LOL-HECO-IR-24

Ref: "The March 3, 2004 Pukele outage incident has accentuated the need to proceed with the project." (Exhibit ST-4, page 12, lines 15-16)

HECO Report

Pukele Substation Outage

Figure 2 Koolau-Pukele 138kV Transmission Lines

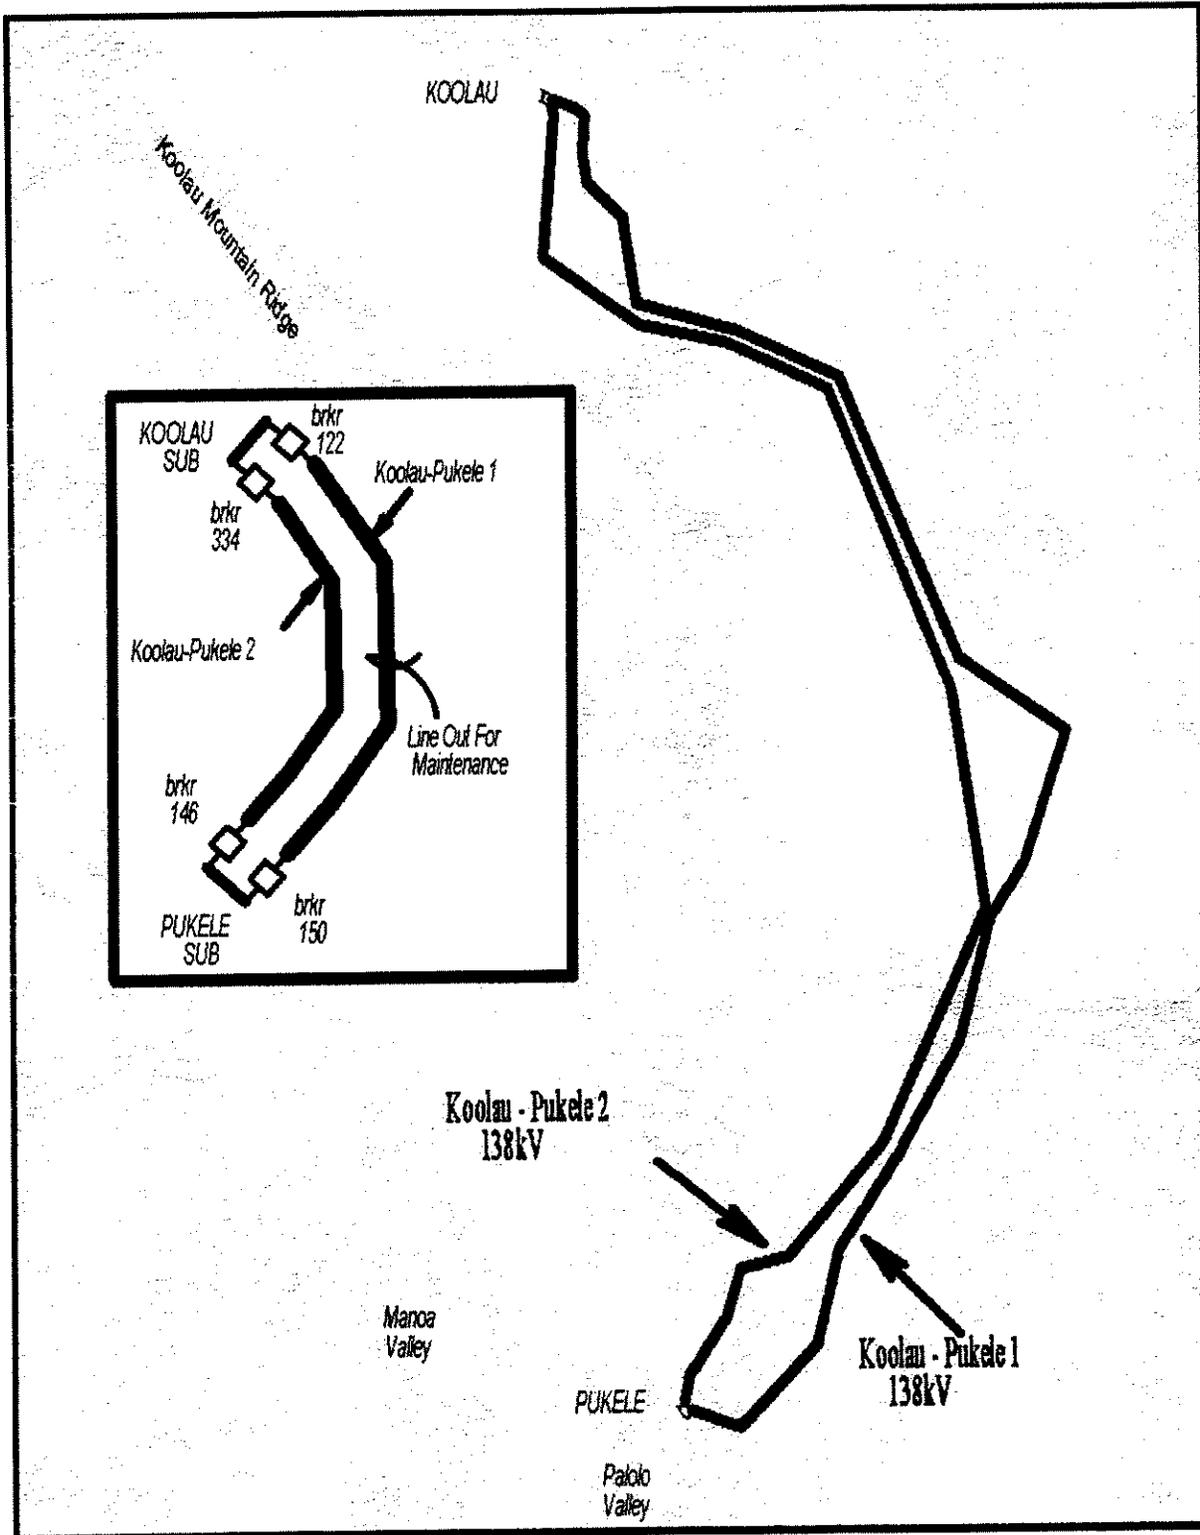
At 6:03 a.m. the Koolau-Pukele No. 1 138-kilovolt transmission line was de-energized by opening circuit breakers 150 and 122 to support planned work (See Figure 2). The scheduled work involved the upgrading of Structure 18 on this line from a wooden pole to a new steel pole. The Pukele Substation is being powered from the remaining Koolau-Pukele No. 2 138-kilovolt transmission line.

The Koolau-Pukele No. 1 138-kilovolt transmission line will be used as an example (refer to Figure 2). Assuming Koolau Breaker No. 122 is tripped due to a protective system action or manual intervention, the relay protection scheme uses a "fast trip" function to immediately trip the corresponding breaker at the Pukele Substation (Breaker No. 150) to de-energize the transmission line.

Figure 4 Basic Communications Path for the Koolau-Pukele #2 138 kV line

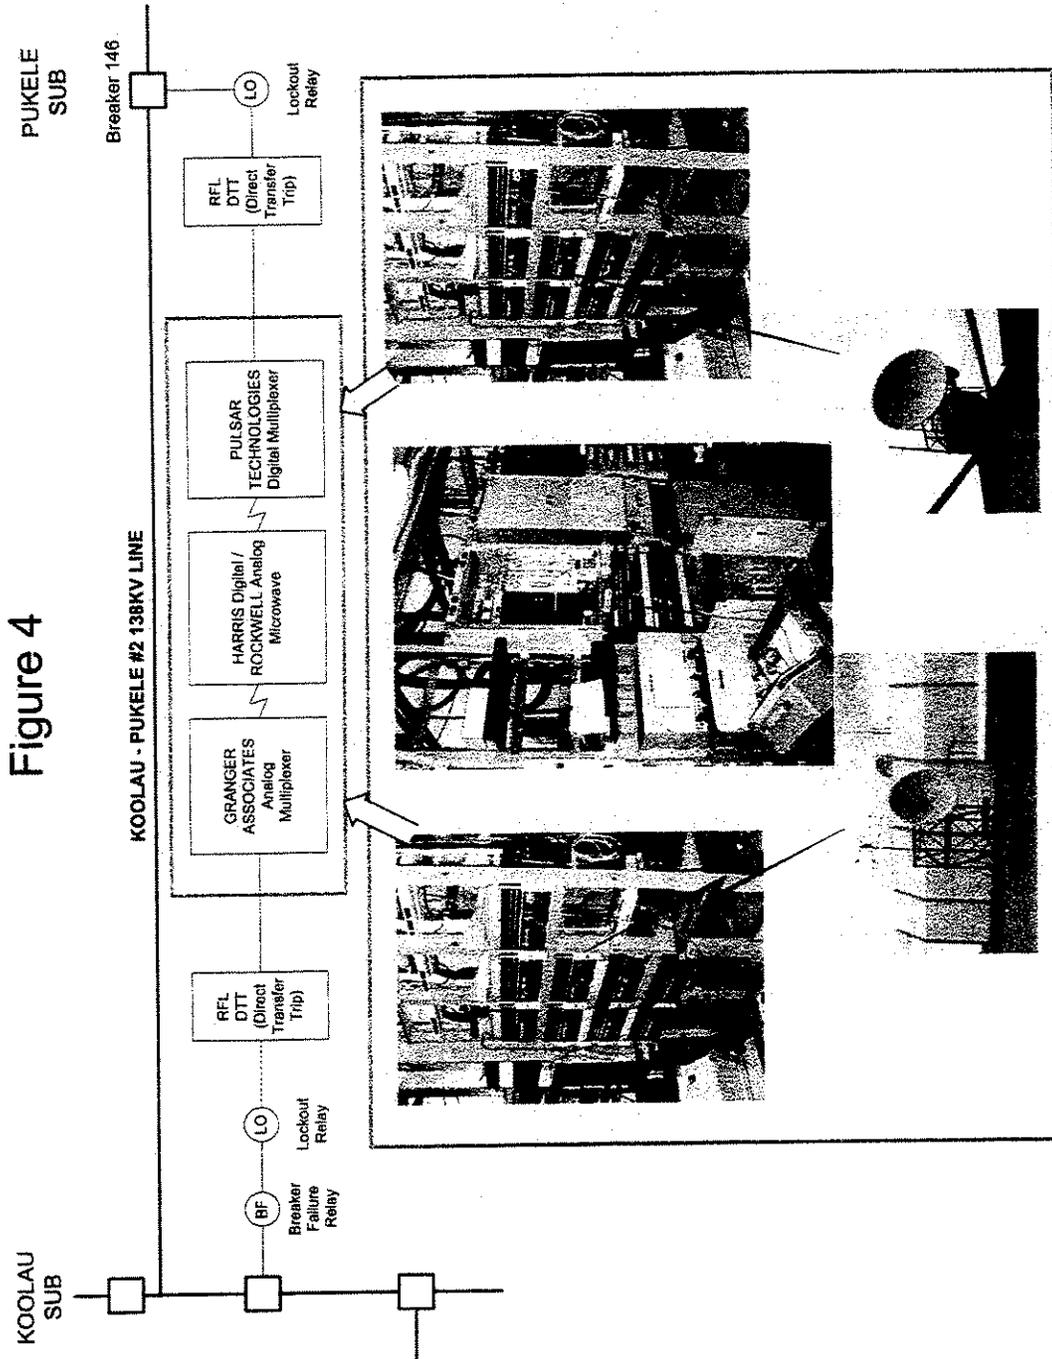
the transmission line in order to de-energize the line quickly. As discussed earlier, the electronic trip signal is sent from the transfer trip tone signal at Koolau to the multiplexer, and through the communications system where it is received at Pukele, routed via a multiplexer and converted back to an electronic trip signal and sent to the DTT. If the DTT recognizes the signal as a valid trip signal, it energizes the lockout relay, which in turn trips Breaker No. 146. See Figure 4 for the flow path.

The lockout relay allows a small signal current to operate the high current relay demand of the 138 kV breaker trip mechanism (See Figure 4). If no relay is used, the large current will damage the DTT electronics.

Figure 6 DC Voltage Relay 74 RAW

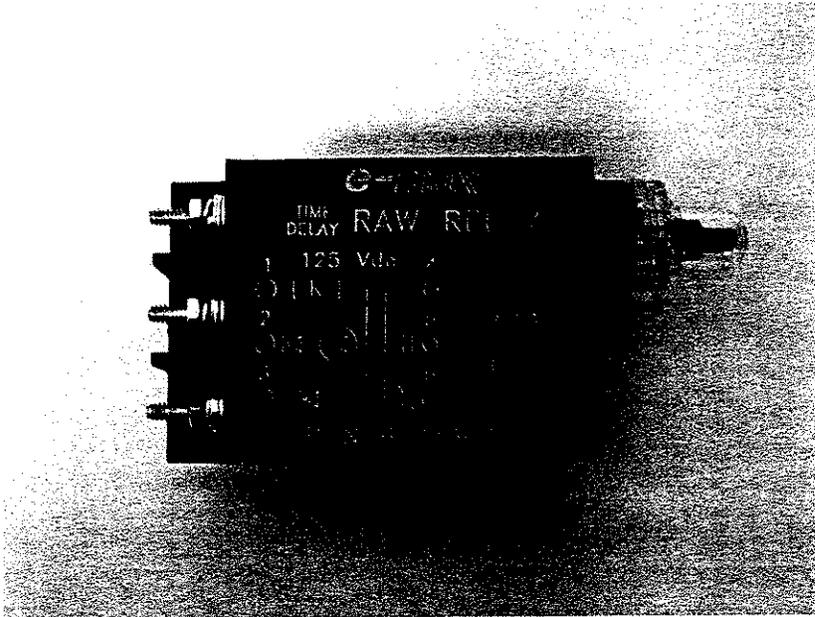
Situation 2 was initially thought to be a potential cause of the unexpected operation of the DTT scheme at Pukele Substation. Upon replacing the relay, it turned out that the LED indicator lamp was shorted. A bench test of the relay, witnessed by Power Engineers, Inc., indicated that despite the shorted indicator lamp, only 6 milliamps more passed through the device compared to a similar relay. It was within normal specifications. It takes approximately 1 ampere (1000 milliamps) of current to “pick up” or energize the trip coil at Pukele Substation. Situation 2 was therefore ruled out as a possibility (See Figure 6).

Figure 1 - T1 Framing with channel-hopping illustration.

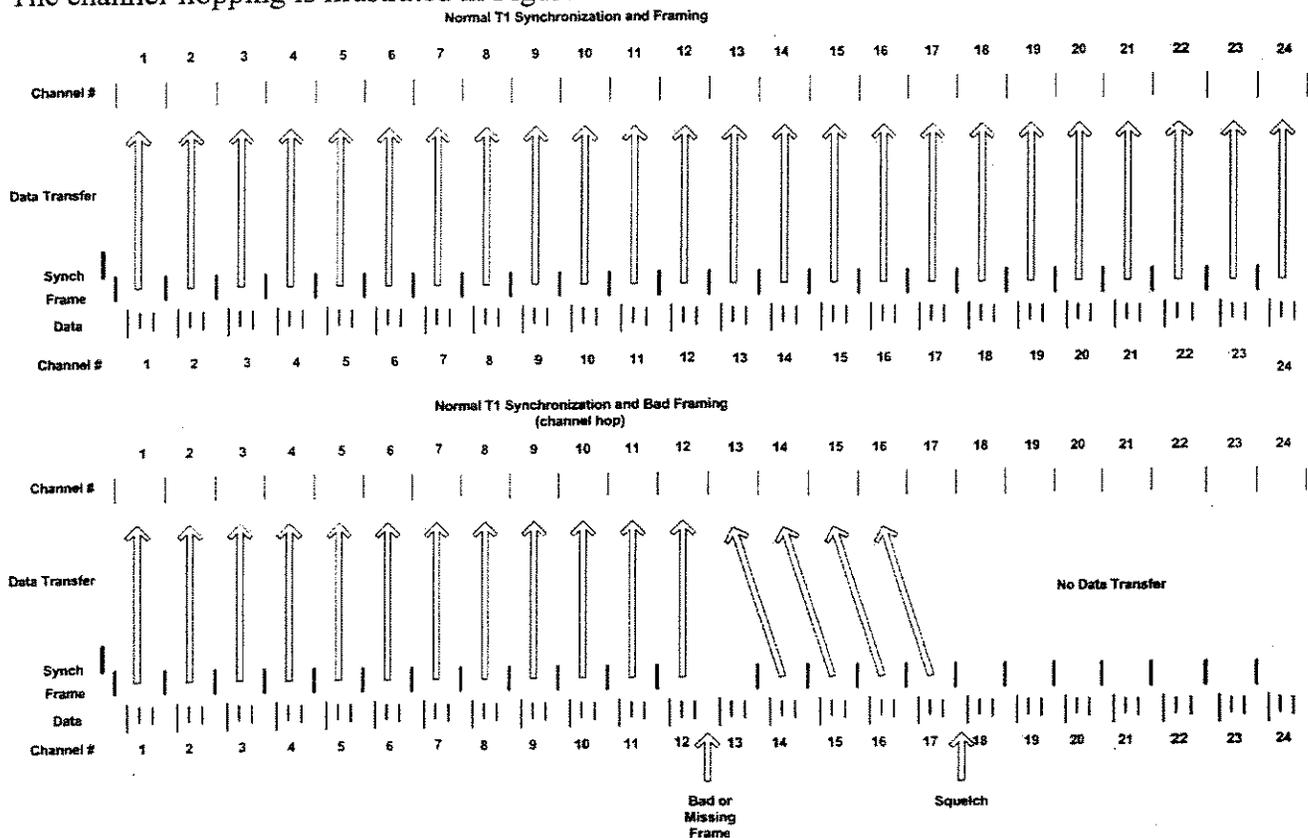
6. The communication system could lose "Synchronization" and divert a standing POTT permissive signal from the POTT channel to the DTT channel resulting in a trip. This seems to be the most likely possibility and is discussed in more detail below.

The channel-hopping is illustrated in Figure 1.
